Groundwater Transfer Review Summary Form

Transfer/PA # T- 14473

Application: T-14473

Applicant Name: City of Redmond

Figure 2. Stream Depletion Modeling Scenario from Gannett and Lite (2004)

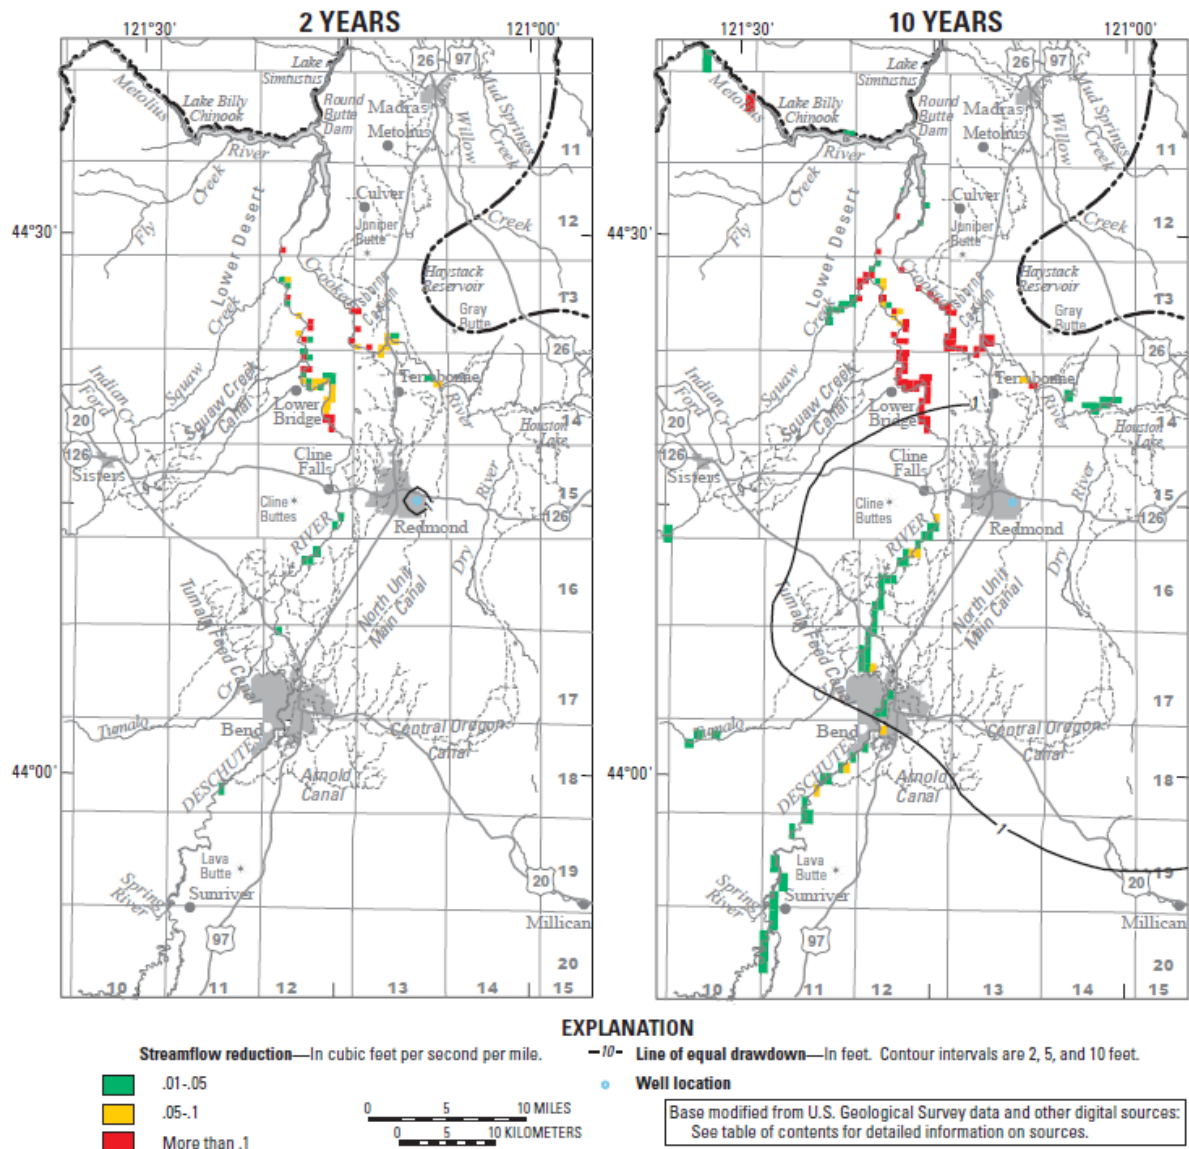
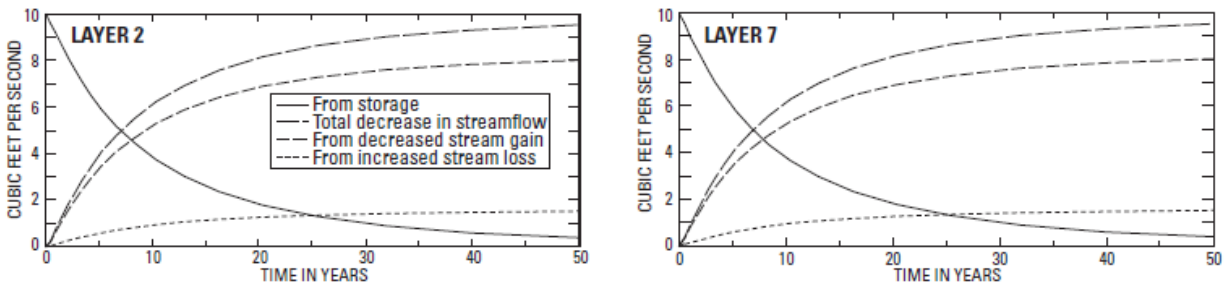
☐ Yes ☒ No Comments: The proposed POAs are located 1.5 to 5 miles from the Deschutes River and the originating POD. The Gannett and Lite (2004) modeling scenario in Figure 2 indicates that 50% stream depletion would occur after 8-9 years of pumping, which does not meet the definition of similarly (>50% stream depletion after 10 days of pumping) in OAR 690-380-2130. Conversely, OAR 690-380-2130(3)(d) indicates that, in DGWSA, the POAs are exempt from the typical 500 ft and 1000 ft proximity requirements for SW-GW transfers and that “the Department may not require that the use of the new point of diversion affect the surface water source similarly....”

- The proposed POAs would impact significantly impact the Crooked River which is NOT the source identified in the originating certificate,
- pumping at the proposed POAs would result in unmitigated stream depletion to the Crooked River,
- pumping at the proposed POAs would reach 50% stream depletion in approximately 8-9 years, which is much longer than the 10-day benchmark required in the definition of similarly.

As a result, this review determines that the proposed transfer does not meet the requirements detailed in OAR 690-380 and ORS 540.531.
